INDIANA DEPARTMENT OF ENVIRONMENTAL MANAGEMENT

Re: NPDES Permit No. IN0063711
ArcelorMittal Indiana Harbor, LLC –
Central Wastewater Treatment Plant
East Chicago, Indiana
Lake County

A response to the comments received pertaining to the draft NPDES permit is contained in the Post Public Notice Addendum. The Post Public Notice Addendum is located at the end of the Fact Sheet.

INDEX
for
ArcelorMittal Indiana Harbor Central Wastewater Treatment Plant NPDES Permit IN0063711

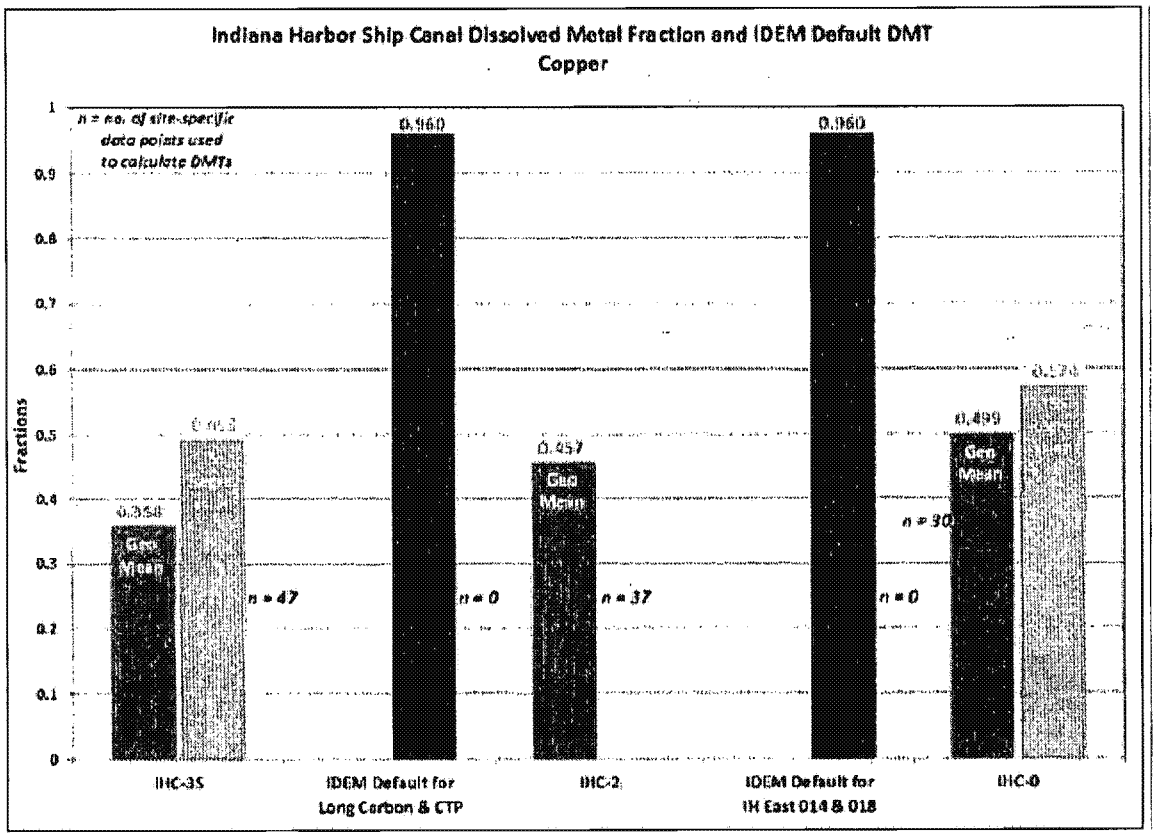
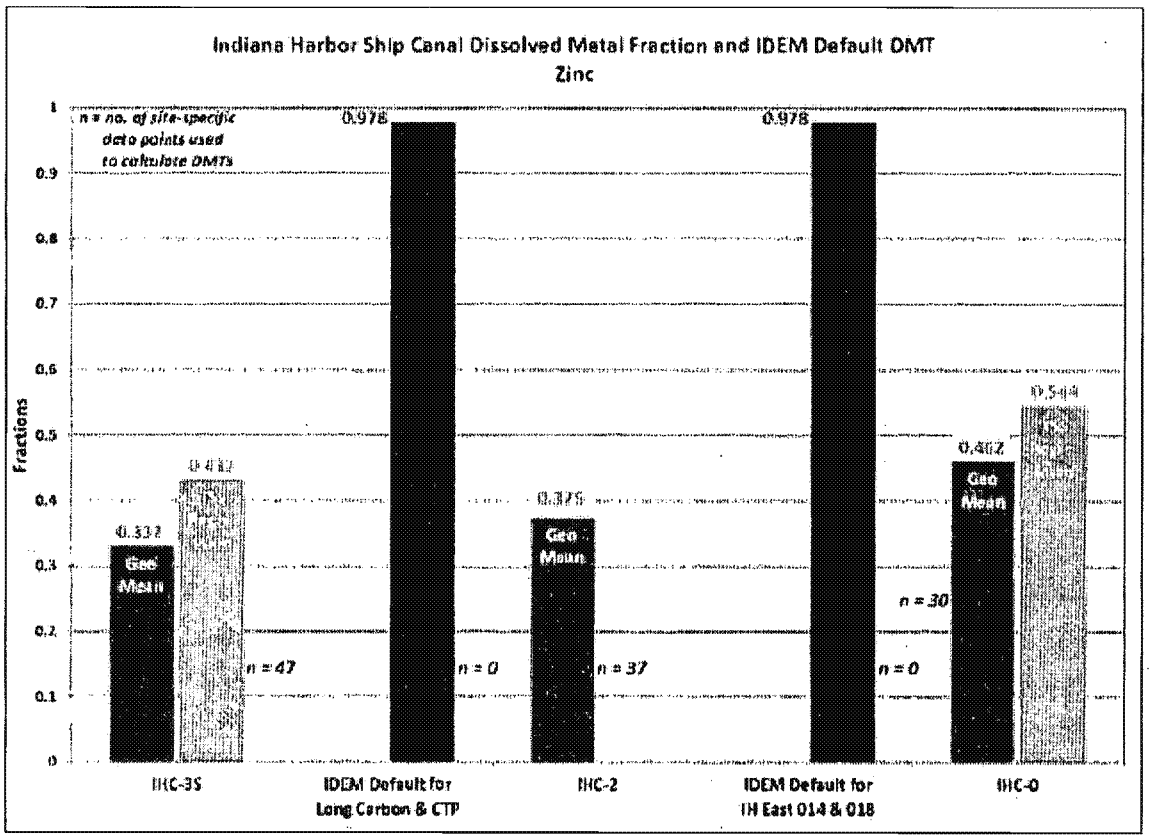
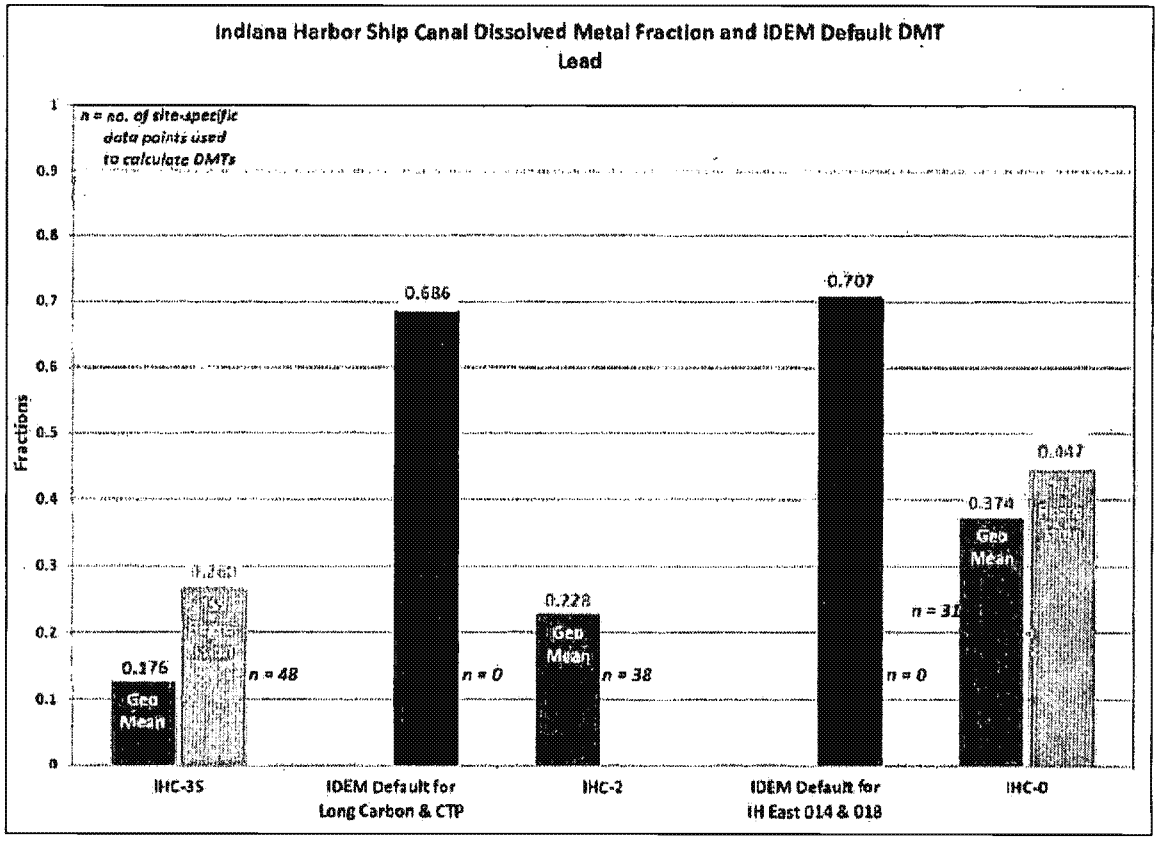
IDEM's default DMTs, which rely on no data specific to the IHSC, are clearly inaccurate for the ArcelorMittal permits and overestimate the dissolved copper, lead and zinc fractions in the IHSC by significant amounts. For example, the default translators are 2.1, 3.0 and 2.6 times greater than the calculated geometric mean of the dissolved fractions for copper, lead and zinc, respectively, at IHC-2. Even the 95th percentiles of the dissolved fractions for all metals at all locations are significantly below IDEM's default translators. As shown, the DMTs calculated at IHC-3S, IHC-2 and IHC-0 are considerably lower than IDEM's default DMTs used in the calculation of WQBELs. Graphs of the geometric mean dissolved fractions, TSS-regression developed DMTs, and IDEMs default DMTs are presented below.

Given the data presented in the table and graphs above, it is not reasonable to assume, as IDEM has done through use of the default DMTs, that the dissolved metal fraction in the water column somehow increases dramatically in between the fixed monitoring stations. ArcelorMittal's requested effluent limits, based upon site-specific DMTs derived from the IDEM fixed monitoring station data and other factors, are presented below.

1. WATER QUALITY-BASED EFFLUENT LIMITS (WQBELs)

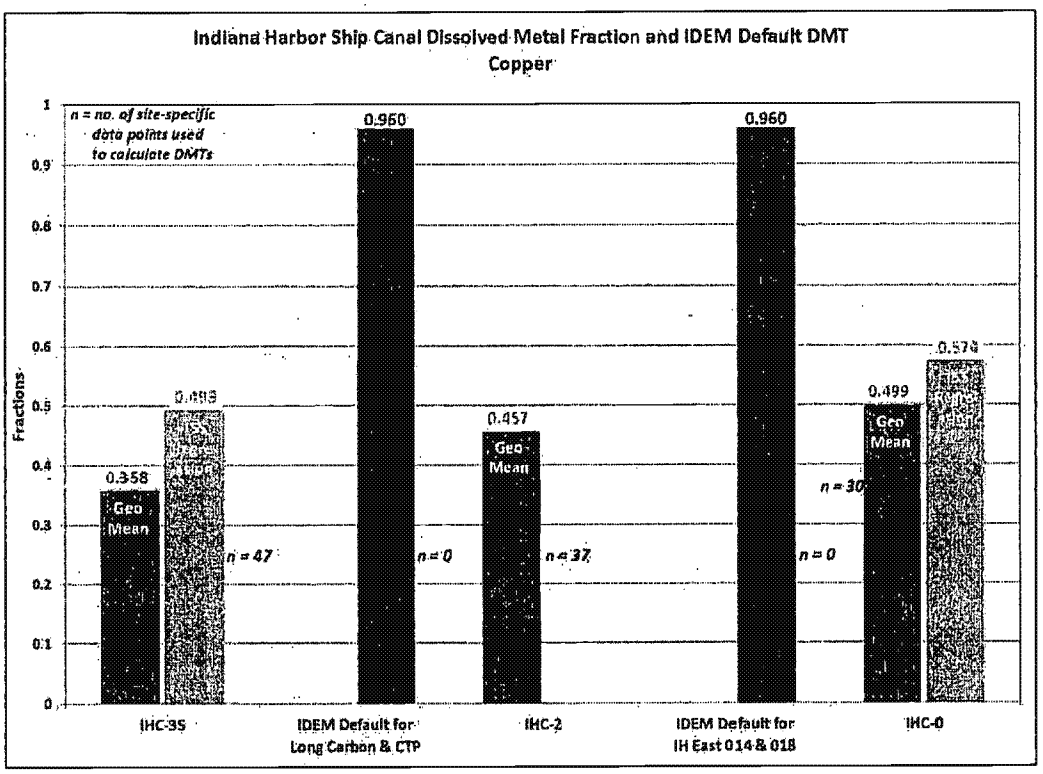
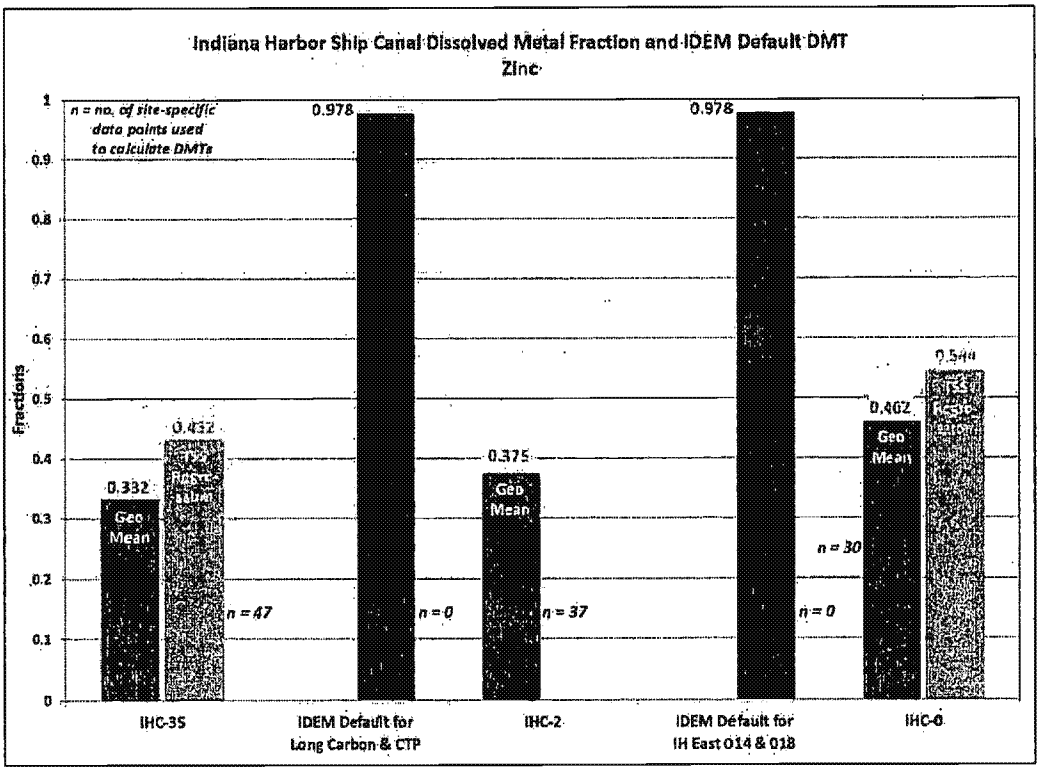
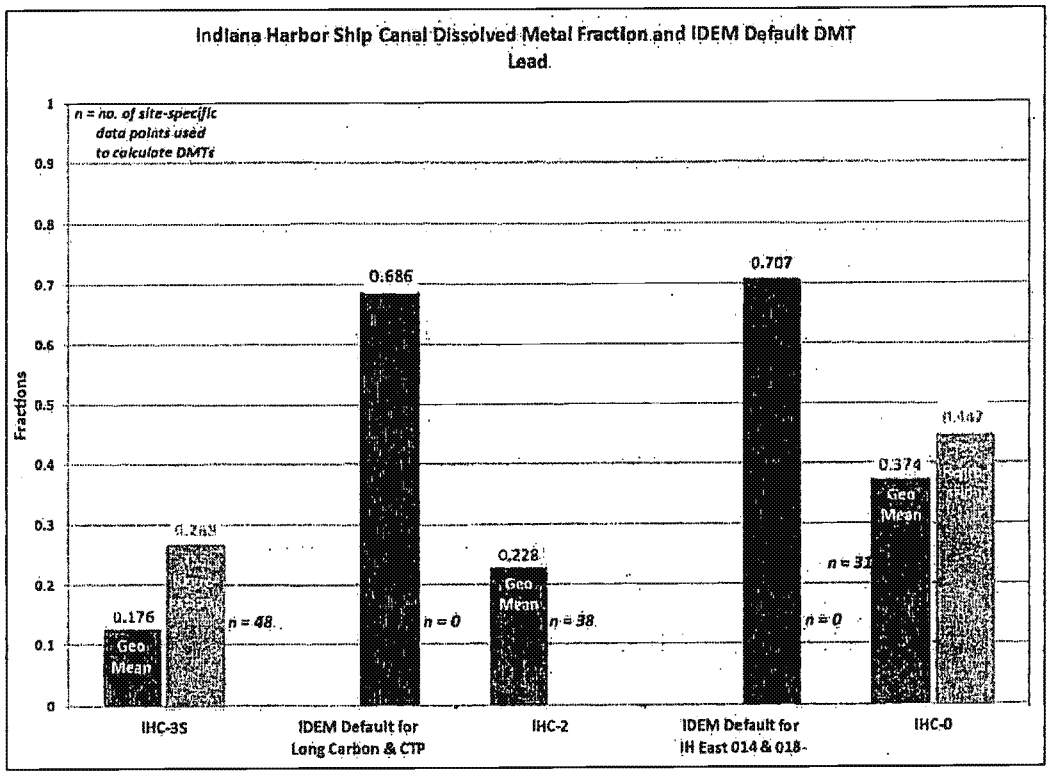
Given the data presented in the table and graphs above, it is not reasonable to assume, as IDEM has done through use of the default DMTs, that the dissolved metal fraction in the water column somehow increases dramatically in between the fixed monitoring stations. ArcelorMittal's requested effluent limits, based upon site-specific DMTs derived from the IDEM fixed monitoring station data and other factors, are presented below.

FIGURE 1

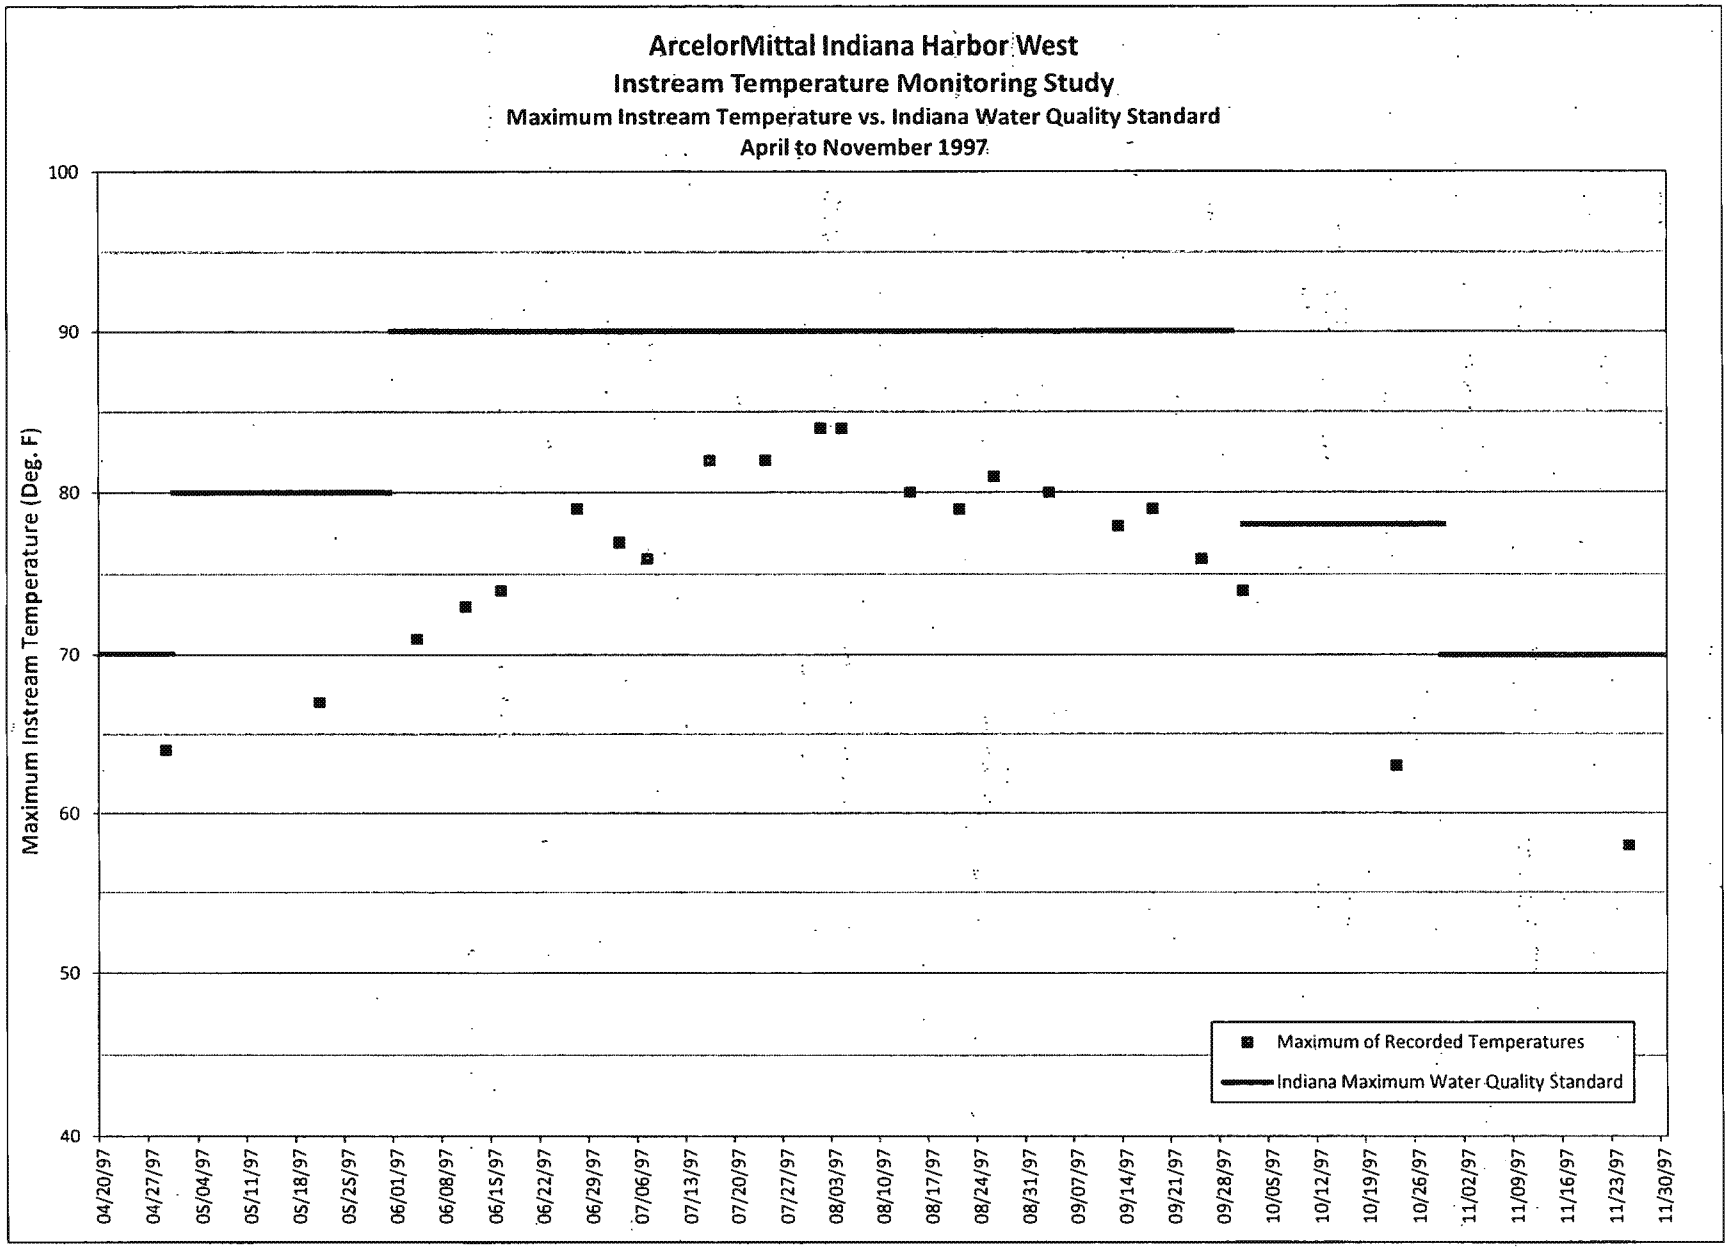
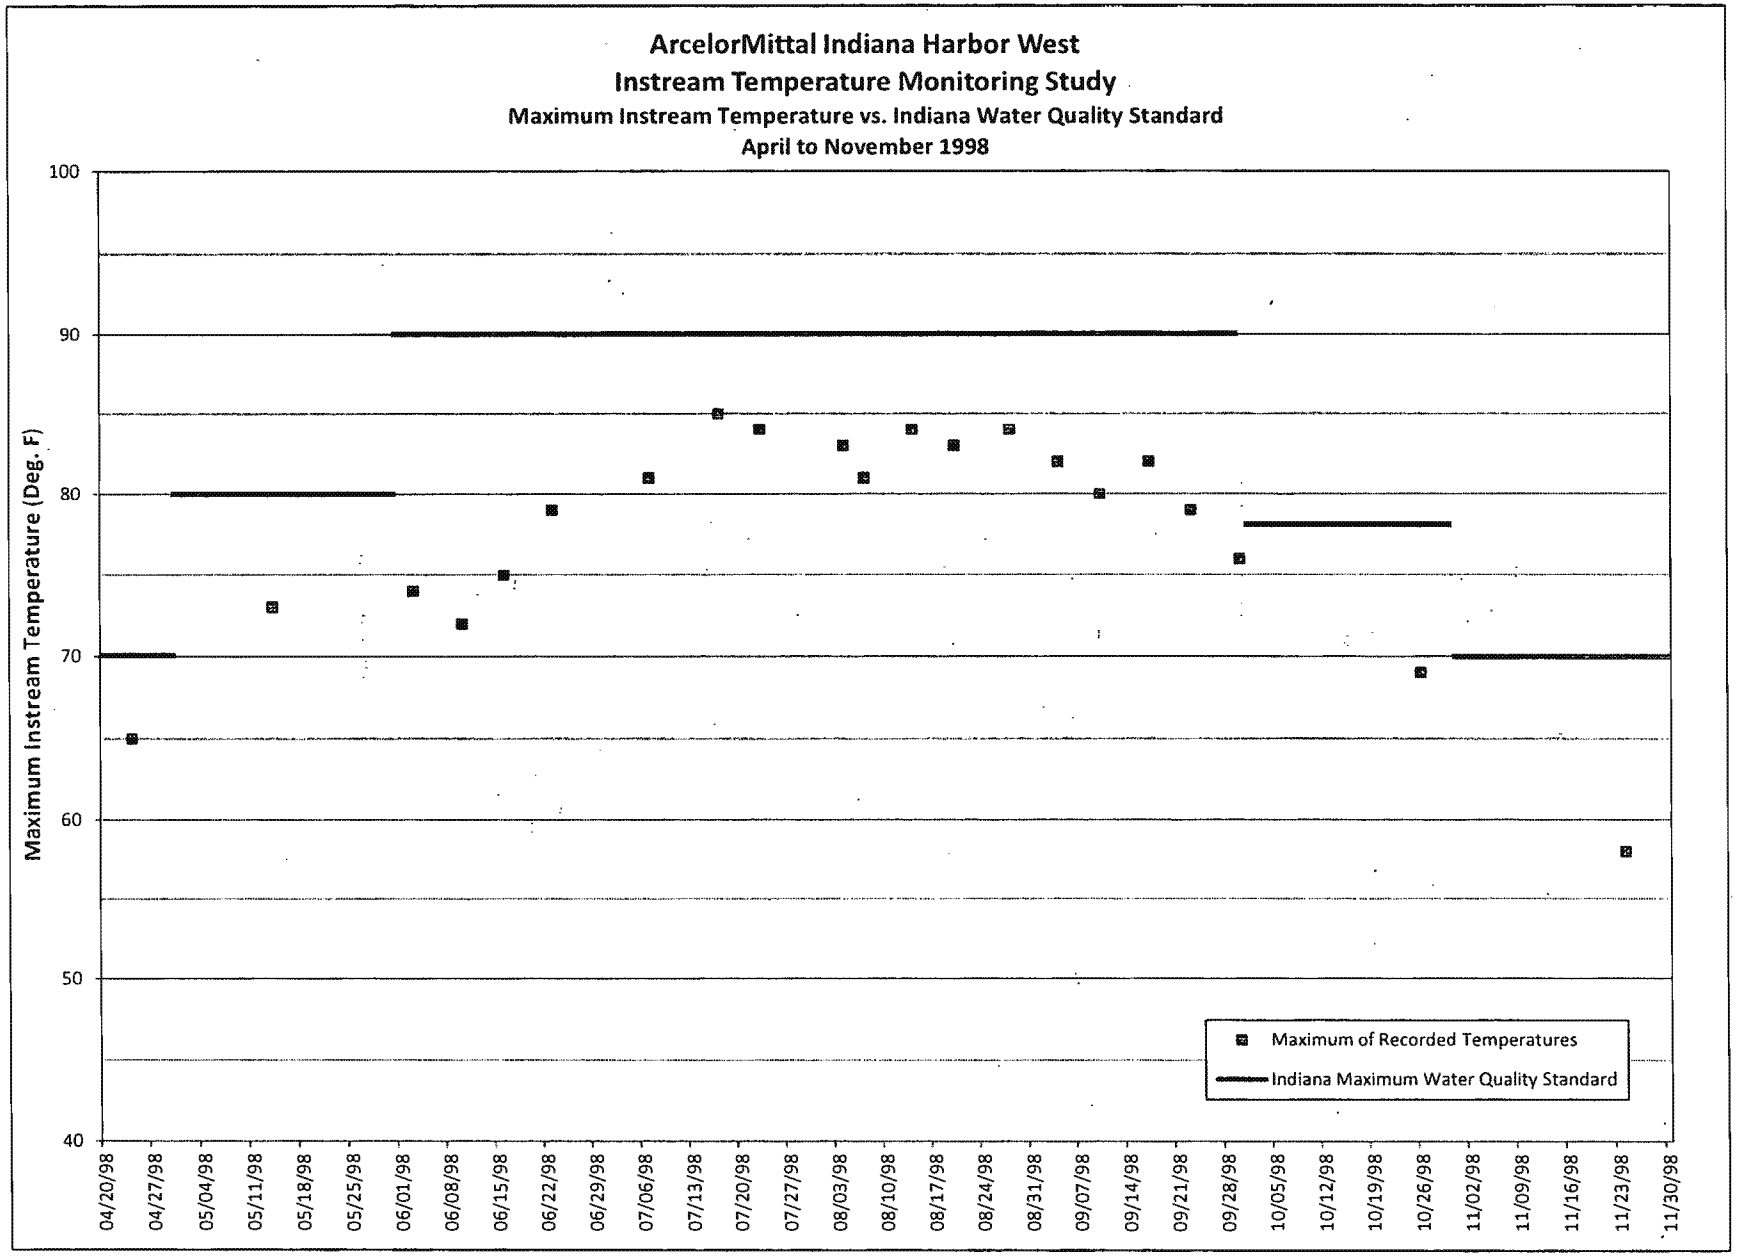
The in-stream temperature monitoring data show maximum temperature water quality standards were met at all locations monitored in 1997 and 1998. The results are shown graphically in Figures 1 and 2.
